SERVICE LETTER

SL 2007-002

MODIFICATION OF TANK HARDPOINTS AND STRUTS

Used On: 208 SPRAY SYSTEM S/N 208-203-005
FOR INSTALLATION ON
BELL HELICOPTER MODEL 407 ROTORCRAFT S/N 53618, TAIL NUMBER N618TS

Figure 1-1 (Sheet 1 of 2), Forward Attachment Fitting Installation (Bell Gear)

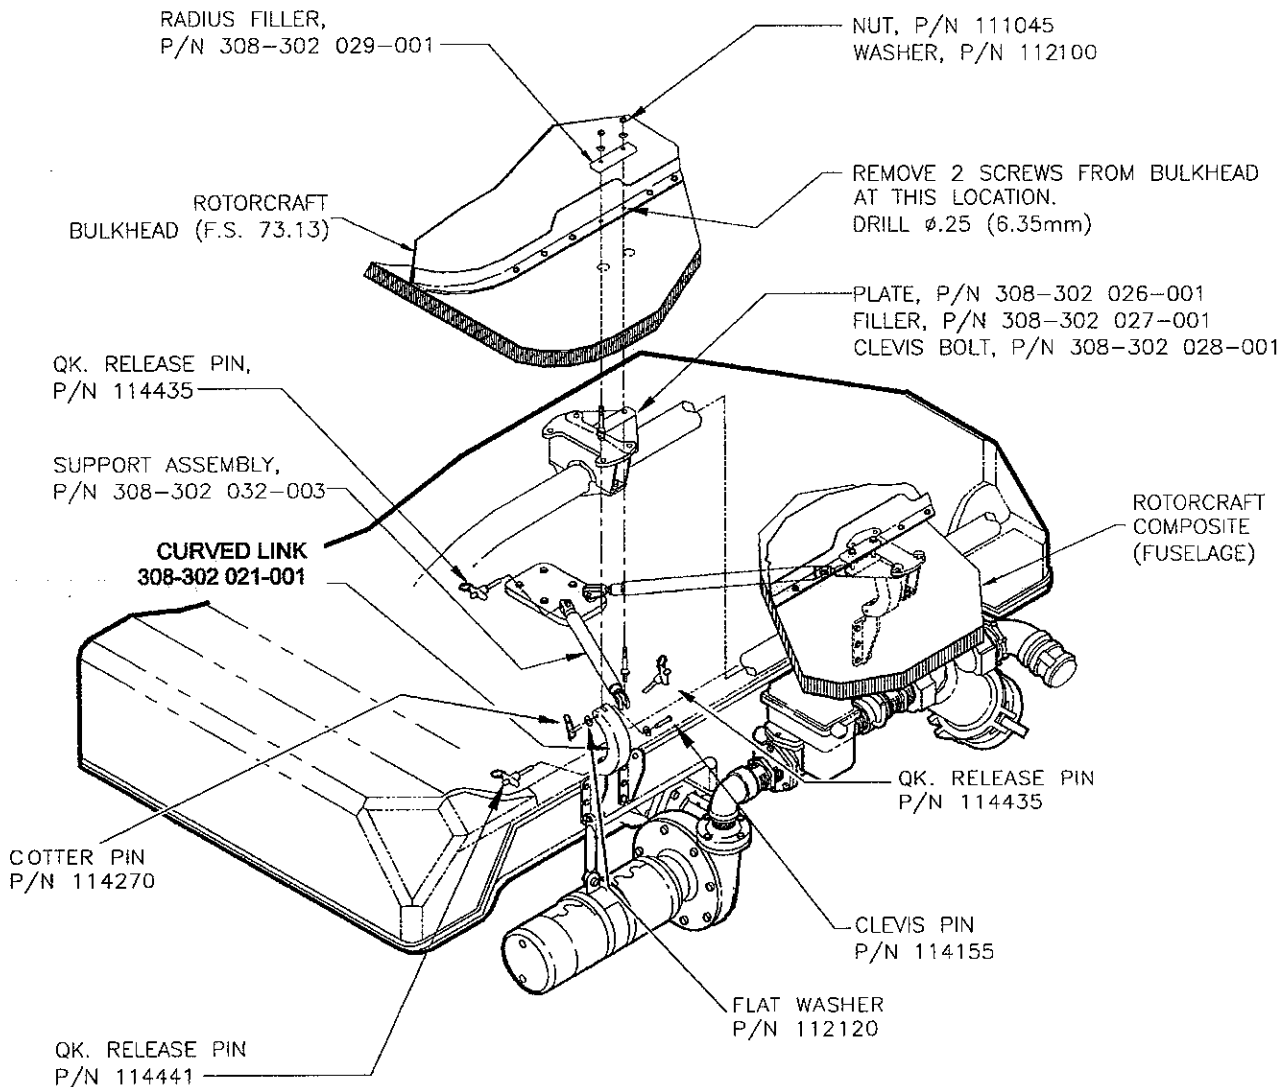
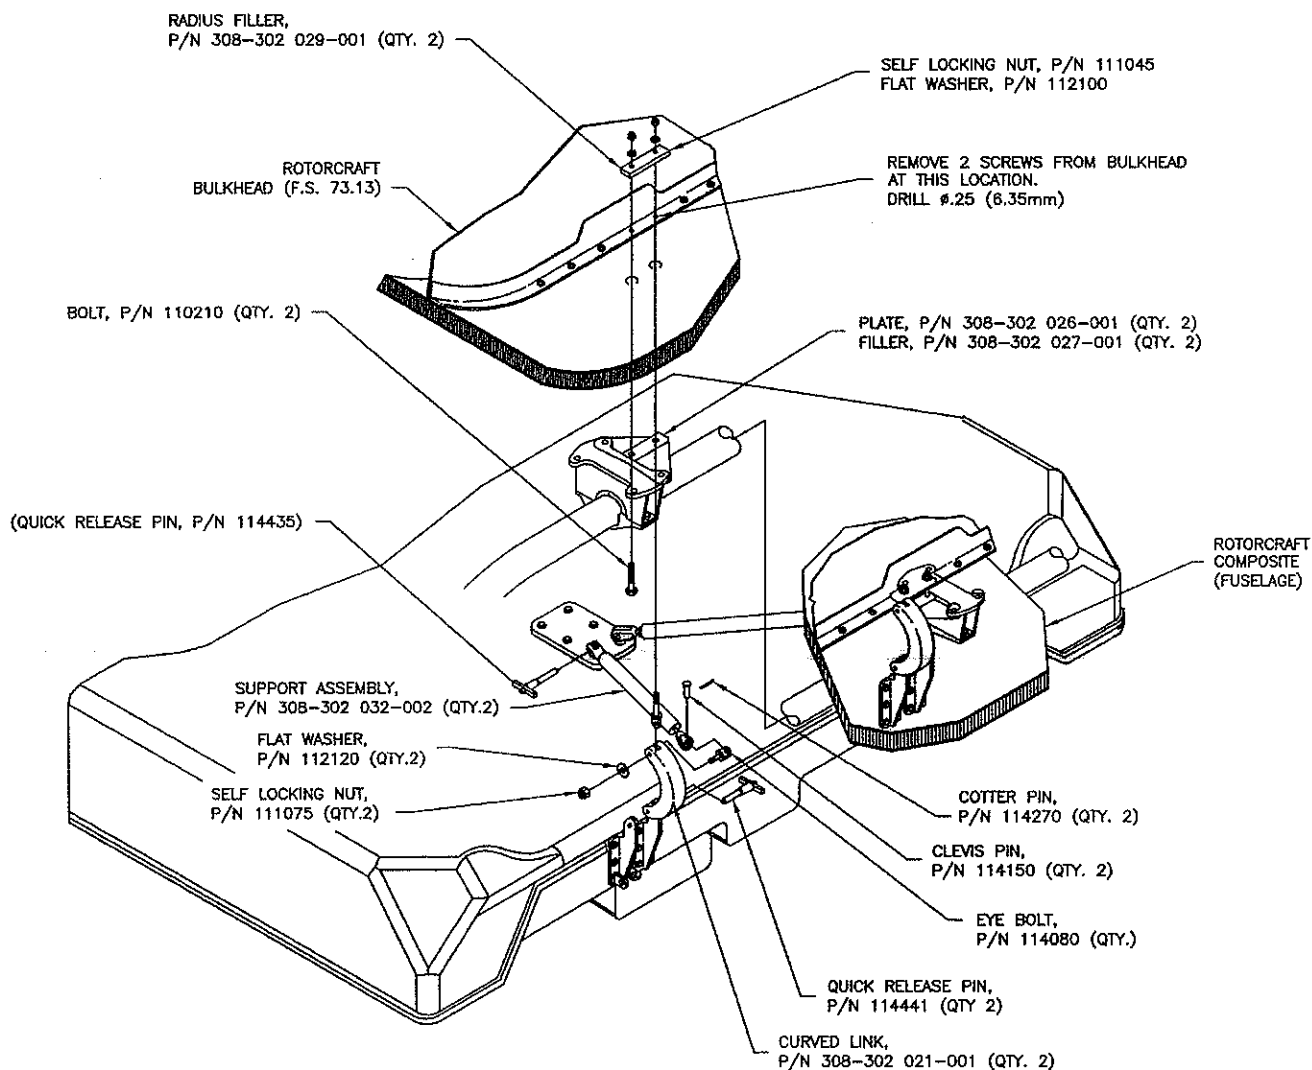
- a. Remove the pilot's and co-pilots seats and panels, exposing inner skin and forward portion of bulkhead (F.S. 73.13).
- b. Remove the two screws from the bulkhead support angle that are located at FS 72.75 and BL 10 and BL12 below the Pilot's seat. These are the fourth and fifth screws from the center console visible under the Pilot seat at the aft bulkhead on the left side of the aircraft, the third and fourth screws on the right side. (Figure 1-1)

- c. Using a long ¼" twist drill, drill down through the two potted inserts the screws were removed from in step b. It may be necessary to remove some Bell brackets and equipment to get the drill to line up. Re-install per the applicable Bell manual after the attachment fittings are installed. (Figure 1-1)

- d. Install one Clevis Bolt (P/N 308-302 028-001) in the outboard ¼" hole and install one Filler (P/N 308-302 027-001) below the skin. Temporarily secure with a nut and a stack of washers to clamp up. Align Filler laterally across the aircraft. It may be necessary to remove some of the sealant on the gear fitting. (Figure 1-1)

- e. Drill ¼" through Filler (P/N 308-302 027-001) from the top through the inboard ¼" hole drilled in step c. (Figure 1-1)
- f. Remove the both inboard NAS6604-7 fasteners securing the forward cross tube fitting to the rotorcraft. (FS 70.56 and FS75.44 and BL12.13). (Figure 1-1)

- g. Remove the Clevis Bolt installed in step d.
- h. Install the Plate (P/N 308-302 026-001) below the existing gear fitting with two Bolts (P/N 110241, NAS6604-9) and washers removed earlier re-securing the fitting to the aircraft. Make sure that the Filler (P/N 308-302 027-001) stays in place. (Figure 1-1)

- i. From the top, using a ¼" drill, drill through the Filler (P/N 308-302 027-001) 1 hole. (Figure 1-1)
- j. Locate the Radius Filler (P/N 308-302 029-001) against the bulkhead (FS 73.13) and centered left and right over the two ¼" holes. The angled portion of the Radius Filler is aft against the bulkhead with the angle on the Radius Filler matching the angle of the bulkhead. (Figure 1-1)

Figure 1-2 Forward Aircraft Modification

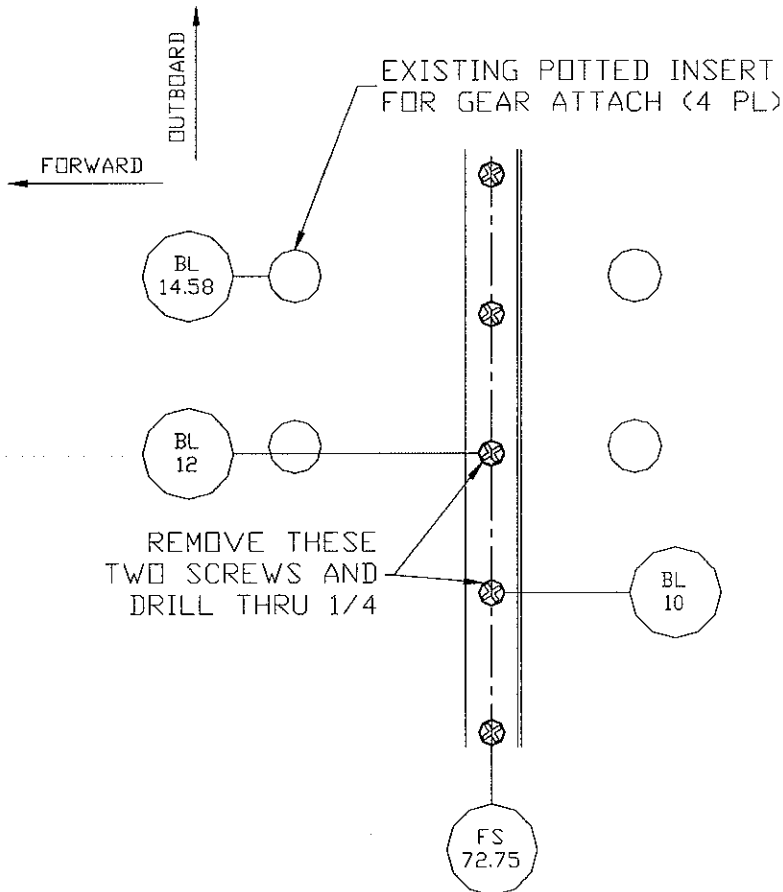
- m. Using the 1/4" bit, drill through the Radius Filler up from the bottom through the outboard 1/4" hole.
- n. **(Bell Gear)** Install one Clevis Bolt (P/N 308-302 028-001) from the bottom and secure with Nut (P/N 111045 MS21044C4) and Washer (P/N 1120100 AN960C-416). The Clevis bolt aligns with the lug fore and aft. 50 to 70 in.-lb. (Figure 1-1, 1-2) **(Aeronautical Accessories Gear)** Install one bolt (P/N 110210) from the bottom through the outboard hole. Secure with nut (P/N 111045) and washer (112100).(Figures 1-2, 1-5)

Figure 1-4, Clevis Bolt Orientation (View looking up, left side of aircraft)

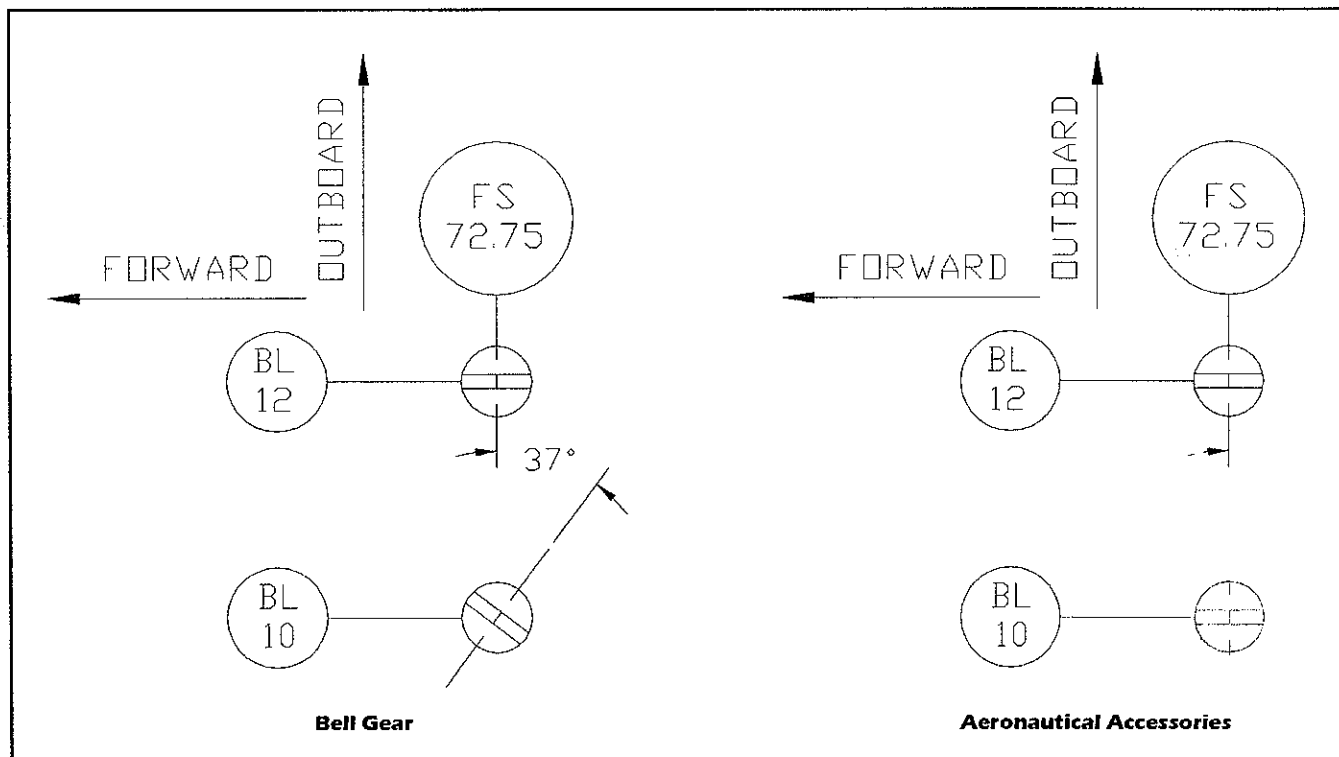
- k. Using a short $\frac{1}{4}$ " bit, mark the Radius Filler up from the bottom through the inboard $\frac{1}{4}$ " hole. Remove Radius Filler and drill $\frac{1}{4}$ " at marks. (Figure 1-1)
1. **(Bell Gear)** Install one Clevis Bolt (P/N 308-302 028-001) from the bottom and secure with Nut (P/N 111045 MS21044C4) and Washer (P/N 112100 AN960C-416). The Clevis Bolt aligns with the lug aft end canted 37° toward the aircraft center line. 50 to 70 in.-lb. (Figure 1-3, 1-4) **(Aeronautical Accessories Gear)** Install one Clevis Bolt (P/N 308-302 028-001) from the bottom through the inboard hole. Secure with nut (P/N 111045) and washer (P/N 112100). The Clevis Bolt aligns with the lug aft end parallel to the aircraft center line. 50 to 70 in.-lb. (Figure 1-4, 1-5)

Figure 1-5, Aft Attachment fitting Installation

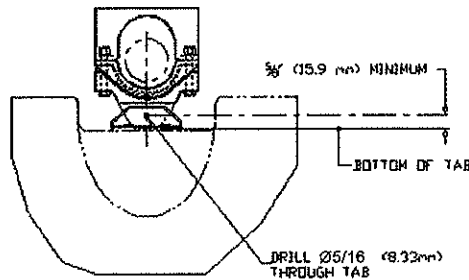
- e. Lift the aft end of the Spray tank so that the angles mounted to the top of the tank align around the tabs on the brackets installed on the cross tube supports. (Fig. 1-5)

Figure 1-6, Aft Rotorcraft Attachment Fitting Installation

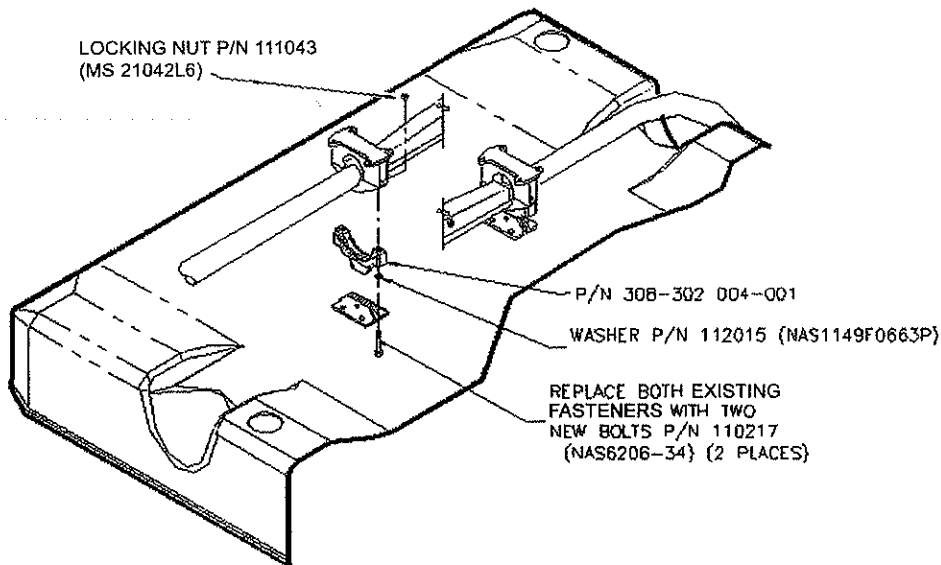
- a. Remove the two NAS6206-10 fasteners securing both aft cross tube straps. (Figure 1-6)
- b. Install P/N 208-302 004-001(bracket, hard-point) to the bottom of the existing cross tube support using new 110217 (NAS6206-34) hardware (supplied) with bolt heads on the bottom, nuts on top. Leave brackets slightly loose until later.
- c. Position the tank with the forward attachment fittings on the tank below the forward attachment fittings installed earlier on the belly of the rotorcraft.
